PCI-SIG ENGINEERING CHANGE NOTICE

TITLE:	Optimized Buffer Flush/Fill
DATE:	Updated 30 April 2009, original request: 8 February 2008
AFFECTED DOCUMENTS:	PCI Express Base Specification, Revision 2.0 PCI Express Base Specification, Revision 2.1 PCI Express CEM Specification, Revision 2.0 PCI Express Mini CEM Specification, Revision 1.2
SPONSORS:	Intel Corporation

Figure 2.x: OBFF Message

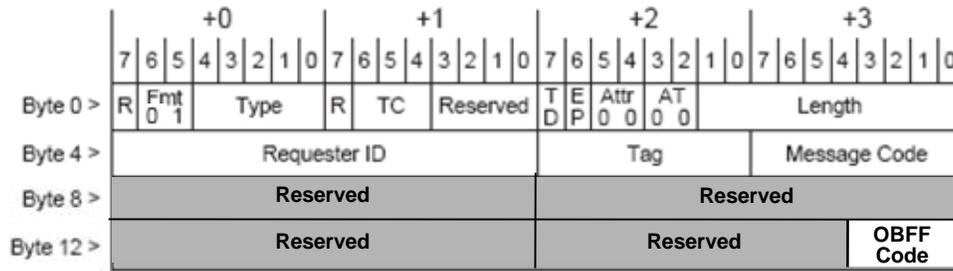
PCI Express Base Specification - add Section 2.2.8.x:

2.2.8.x. Optimized Buffer Flush/Fill (OBFF) Message

15 The OBFF Message is optionally used to report platform central resource states to Endpoints. This mechanism is described in detail in <Section 6.x below>.

The following rules apply to the formation of the OBFF Message:

- <ref table below> defines the OBFF Message.
- The OBFF Message does not include a data payload (TLP Type is Msg).
- 20 The Length field is reserved.
- The Requester ID must be set to the Transmitting Port's ID
- The OBFF Message must use the default Traffic Class designator (TC0). Receivers that implement OBFF support must check for violations of this rule. If a Receiver determines that a TLP violates this rule, it must handle the TLP as a Malformed TLP.
- 25
 - This is a reported error associated with the Receiving Port (see Section 6.2)

Figure 6-x: OBFF Codes and Equivalent WAKE# Patterns

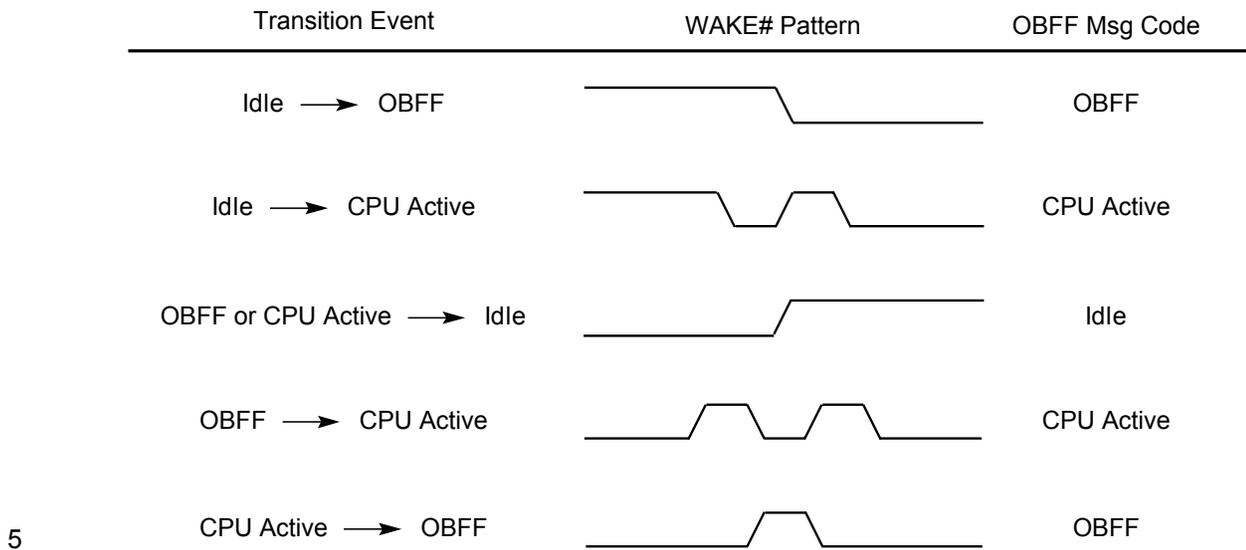
These codes correspond to various assertion patterns of WAKE# when using WAKE# signaling, as shown in <ref figure 6-x below>. There is one negative-going transition when signaling OBFF and two negative going transitions each time CPU Active is signaled. The electrical parameters required when using WAKE# are defined in the WAKE# Signaling section of PCI Express CEM Specification, Revision 2.0 (or later).

When an OBFF Message is received that indicates a Reserved code, the Receiver, if OBFF is enabled, must treat the indication as a “CPU Active” indication.

Figure 06-y: Example Platform Topology Showing a Link Where OBFF is carried by Messages

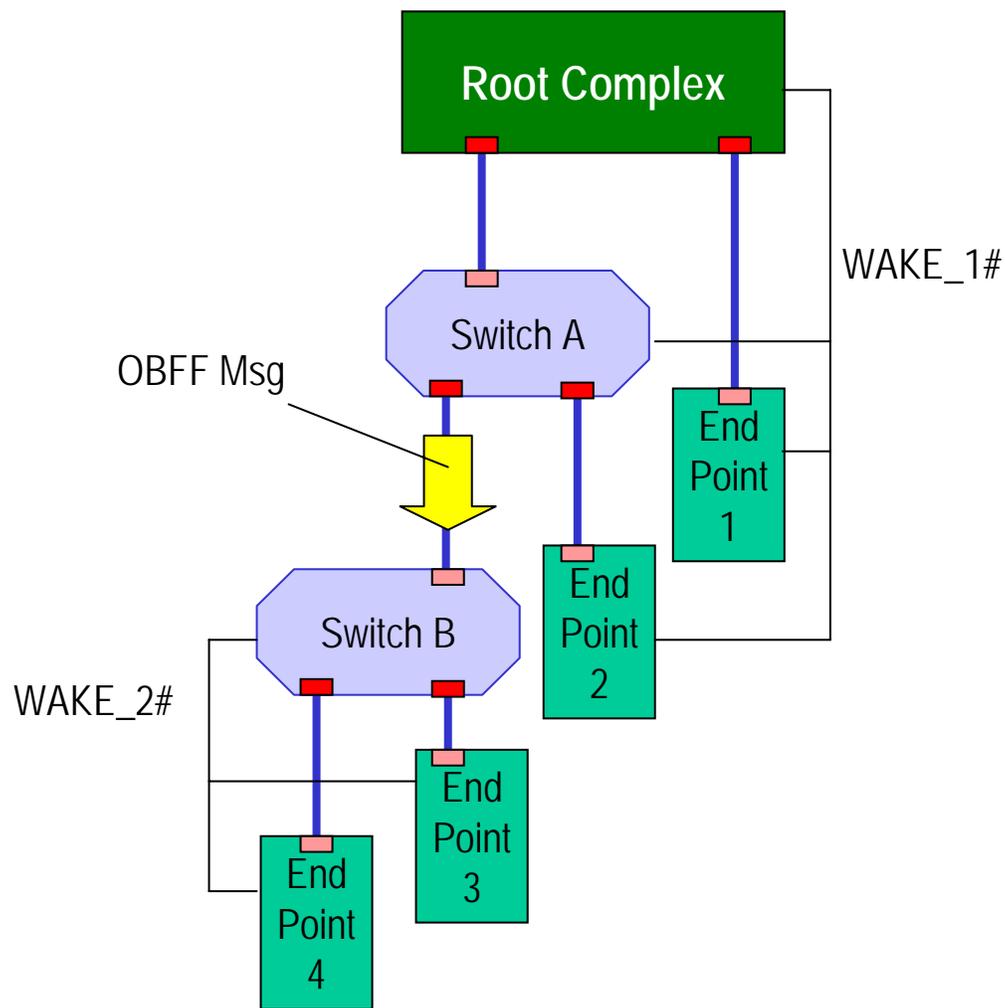
Figure <6-y> shows an example system where it is necessary for a Switch (A) to translate OBFF indications received using WAKE# into OBFF Messages, which in this case are received by another Switch (B) and translated back to using WAKE# signaling. A HwInit configuration mechanism (set by hardware or firmware) is used to identify cases such as shown in this example (where the link between Switch A and Switch B requires the use of OBFF Messages), and system firmware/software must configure OBFF accordingly.

When a Switch is configured to use OBFF Message signaling at its Upstream Port and WAKE# at one or more Downstream Ports, or vice-versa, when enabled for OBFF, the Switch is required to convert all OBFF indications received at the Upstream Port into the appropriate form at the Downstream Port(s).

7.8.15. Device Capabilities 2 Register (Offset 24h)

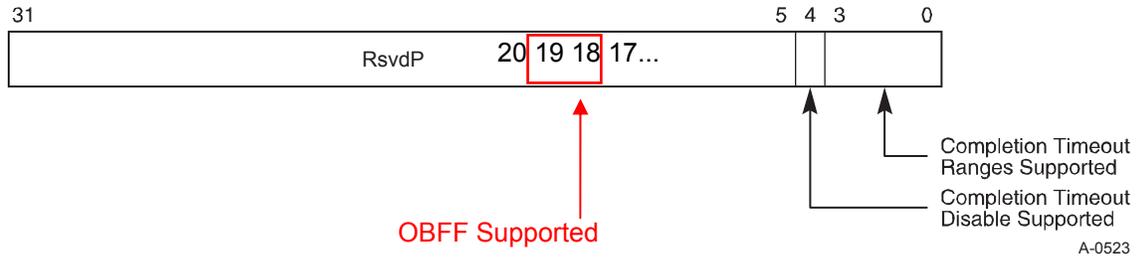
PCI Express Base Specification - change Figure 7-24 and Table 7-23 in Section 7.8.15 as follows:

Bit Location	Register Description	Attributes
...		
<u>19:18</u>	<p><u>OBFF Supported –</u></p> <p><u>00b – OBFF Not Supported</u> <u>01b – OBFF supported using Message signaling only</u> <u>10b – OBFF supported using WAKE# signaling only</u> <u>11b – OBFF supported using WAKE# and Message signaling</u></p> <p><u>The value reported in this field must indicate support for WAKE# signaling only if:</u></p> <ul style="list-style-type: none"> <u>- for a Downstream Port, driving the WAKE# signal for OBFF is supported and the connector or component connected Downstream is known to receive that same WAKE# signal</u> <u>- for an Upstream Port, receiving the WAKE# signal for OBFF is supported and, if the component is on an add-in-card, that the component is connected to the WAKE# signal on the connector.</u> <p><u>Root Ports, Switch Ports and Endpoints are permitted to implement this capability.</u></p> <p><u>For a multi-Function device associated with an Upstream Port, each Function must report the same value for this field.</u></p> <p><u>For Bridges and Ports that do not implement this capability, this field must be hardwired to 00b.</u></p>	<u>HwInit</u>

7.8.16. Device Control 2 Register (Offset 28h)

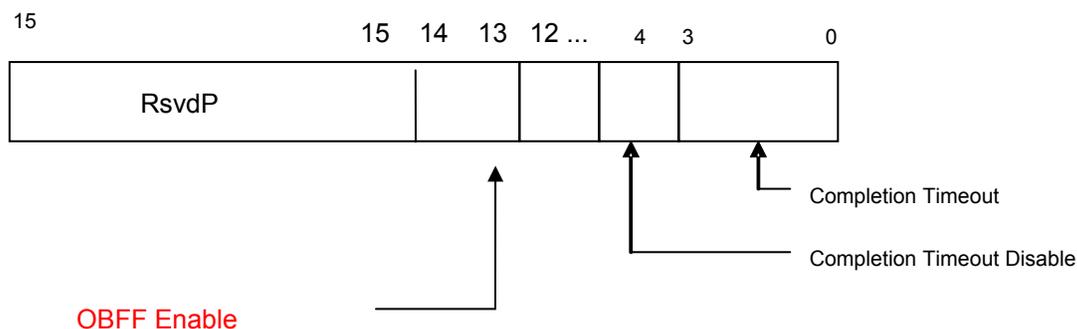
PCI Express Base Specification - change Figure 7-25 and Table 7-24 in Section 7.8.16 as follows:

Bit Location	Register Description	Attributes
...		
<u>14:13</u>	<p><u>OBFF Enable –</u> <u>00b – Disabled</u> <u>01b – Enabled using Message signaling [Variation A]</u> <u>10b – Enabled using Message signaling [Variation B]</u> <u>11b – Enabled using WAKE# signaling</u> See Section <6.x!!!> for an explanation of the above encodings. This field is required for all Ports that support the OBFF Capability. For a Multi-Function Device associated with an Upstream Port of a Device that implements OBFF, the field in Function 0 is of type RW, and only Function 0 controls the Component's behavior. In all other Functions of that Device, this field is of type RsvdP. Ports that do not implement OBFF are permitted to hardwire this field to 00b. Default value of this field is 00b.</p>	<u>RW /RsvdP (see description)</u>

Figure 2-14: WAKE# Rise and Fall Time Measurement Points

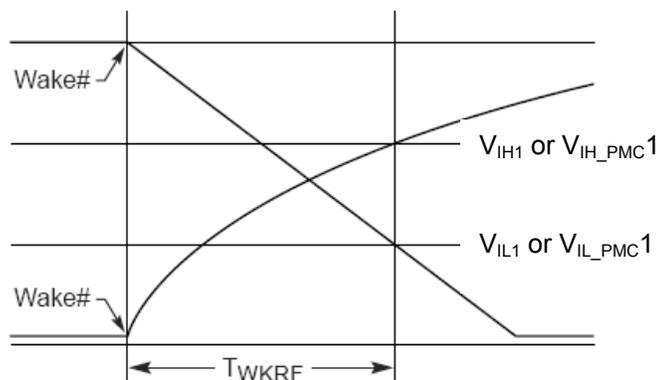
PCI Express CEM Specification - change Table 2-4 and Figure 2-14 in Section 2.6.2 as follows:

Symbol	Parameter	Min	Max	Units	Notes	Figure
T _{PVPERL}	Power stable to PERST# inactive	100		ms	1	<>
T _{PERST-CLK}	REFCLK stable before PERST# inactive	100		μs	2	<>
T _{PERST}	PERST# active time	100		μs		<>
T _{FAIL}	Power level invalid to PERST# active		500	ns	3	<>
T _{WKRF}	WAKE# rise – fall time		100	ns	4	<>
T_{WAKE-TX-MIN-PULSE}	Minimum WAKE# pulse width; applies to both active-inactive-active and inactive-active-inactive cases	300		ns	5	
T_{WAKE-FALL-FALL-CPU-ACTIVE}	Time between two falling WAKE# edges when signaling CPU Active	700	1000	ns	5

- Any supplied power is stable when it meets the requirements specified for that power supply.
- A supplied reference clock is stable when it meets the requirements specified for the reference clock. The PERST# signal is asserted and de-asserted asynchronously with respect to the supplied reference clock.
- The PERST# signal must be asserted within T_{FAIL} of any supplied power going out of specification.
- Measured from WAKE# assertion/de-assertion to valid input level at the system PM controller. Since WAKE# is an open-drain signal, the rise time is dependent on the total capacitance on the platform and the system board pull-up resistor. It is the responsibility of the system designer to meet the rise time specification.
- [Refers to timing requirement for indicating an active window.](#)
